UNITED STATES PATENT AND TRADEMARK OFFICE

APPLICATION NO.	FILING DATE	FIRST NAMED INVENTOR	ATTORNEY DOCKET NO.	CONFIRMATION NO.
10/669,576	09/24/2003	Dieter Hochrainer	1/1401	6795
28501	7590	11/01/2004	EXAMINER	
BOEHRINGER INGELHEIM CORPORATION 900 RIDGEBURY ROAD P. O. BOX 368 RIDGEFIELD, CT 06877			MITCHELL, TEENA KAY	
			ART UNIT	PAPER NUMBER
			3743

Office Action Summary

DETAILED ACTION

FIG. 4A

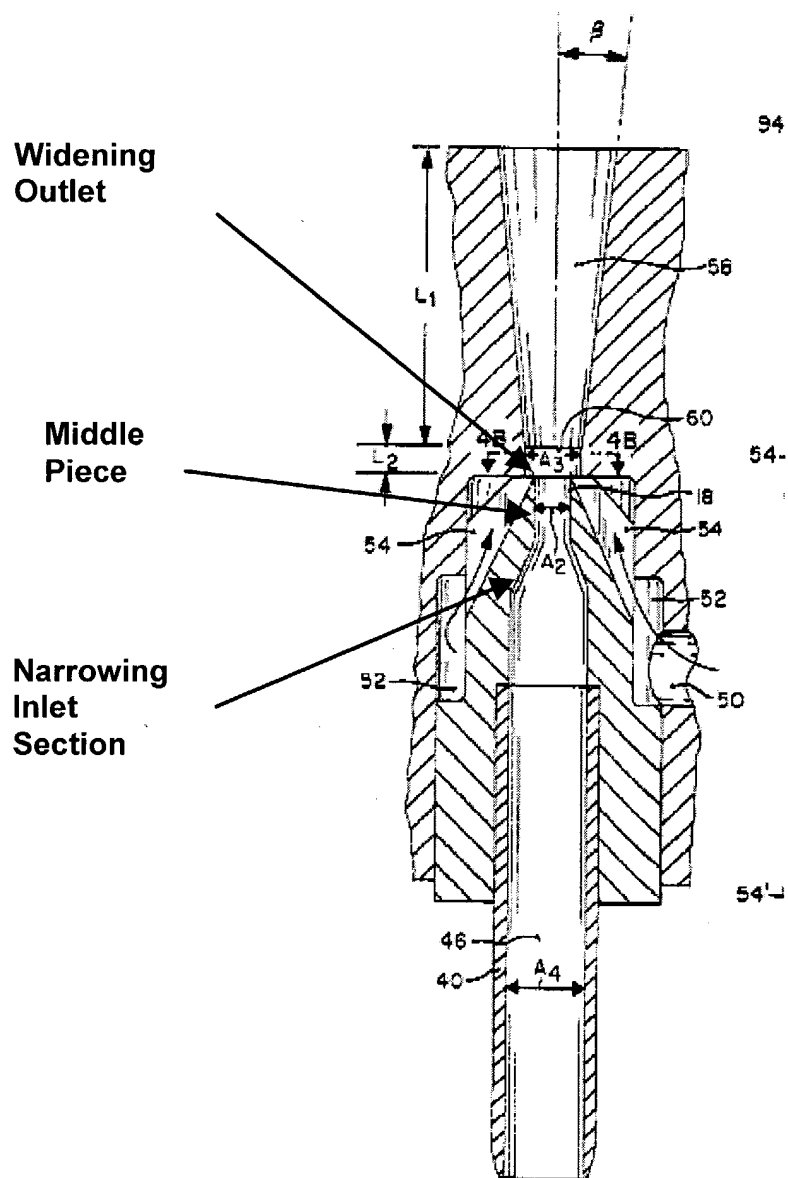
With respect to claim 4, Smith discloses that the nozzle (14) exhibits a narrowing inlet section (see illustration of Fig. 4A below), a middle piece (see illustration of Fig. 4A below) and a widening outlet section (at 58) that connects to the middle piece.

With respect to claim 5, Smith discloses that the narrowest cross section is located in the middle piece (Fig. 4A).

With respect to claim 6, Smith discloses a laval nozzle (14; because a laval nozzle is convergent-divergent nozzle (i.e., venturi-like), the examiner is reading the nozzle of Smith to be a laval nozzle).
